UNITED STATES PATENT AND TRADEMARK OFFICE

Office Action Summary	Application No. 10/579,927	Applicant(s) STEINHARDT ET AL.	
	Examiner YASHITA SHARMA	Art Unit 3774

DETAILED ACTION

Fig. 1

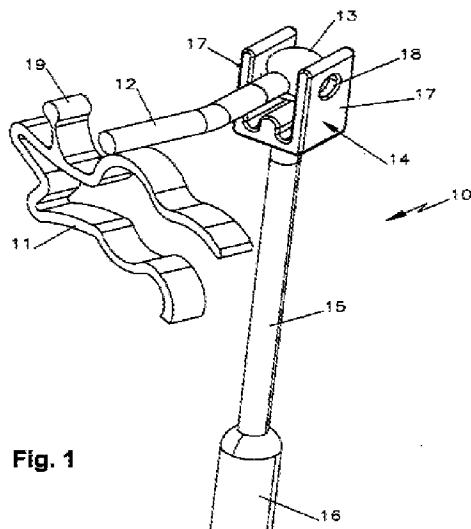
However, Steinhardt teaches a similar device comprising a ball joint ("socket" 14 and a spherical "ball" 13 joint) (Fig. 1) having two struts ("side walls" 17) (Fig. 1), which are solidly joined to a first securing element ("second bar" 15) extend parallel to one another (Fig. 1), and between them enclose a gap like space, in which a ball is pivotably supported in two recesses ("openings" 18) (Fig. 1) in the struts, the elongated shaft ("first bar" 12) is displaceable through the gap like space between the two struts of the ball joint, and the ball snaps in a snapped-in position between the recesses of the struts, in a direction perpendicular to the struts, and the gap like space between the two struts of the ball joint can be made narrower for fixation of the shaft after the desired length has been adjusted (this can be achieved with by manually compressing the parallel struts to an angle). Furthermore, Lee teaches a similar elongated shaft ("rod" 21) comprising a plurality of spherical balls ("beads" 22) wherein desired length of the shaft modulo adjusts the spacing of the balls from one another, and the part of the shaft protruding through and past the first securing element can be cut to length (the free

20. Regarding claim 2, Prescott discloses the claimed invention; except for the two struts of the ball joint are embodied integrally with the first securing element. However, Steinhardt teaches a similar device wherein the two struts ("side walls" 17) (Fig. 1) are embodied integrally with the first securing element ("second bar" 15) (Fig. 1).

device comprising each of the two struts ("side walls" 17) (Fig. 1) of the ball joint ("socket" 14 and "ball" 13 joint) (Fig. 1) has at least one and preferably plurality of recesses ("openings" 18) having shape of round holes (Fig. 1), located side by side, for receiving a ball of the elongated shaft, and two recesses, respectively of the two struts are always diametrically opposite one another (Fig. 1). Therefore, it would have been obvious to one of ordinary skill in the art at the time of invention was made to modify the device in Prescott to include each of the two struts of the ball joint has at least one and preferably plurality of recesses having shape of round holes, located side by side, for receiving a ball of the elongated shaft, and two recesses, respectively of the two struts are always diametrically opposite one another, as taught and suggested by Steinhardt, for the purpose of providing recesses that will allow the ball of the ball and socket joint to be placed securely and prevent any unwanted sliding of the ball out of the recesses while still allowing for a degree of pivoting flexibility to the ball. Furthermore, the round hole shape allow for a better fit of the spherical shape of the balls in the recesses.
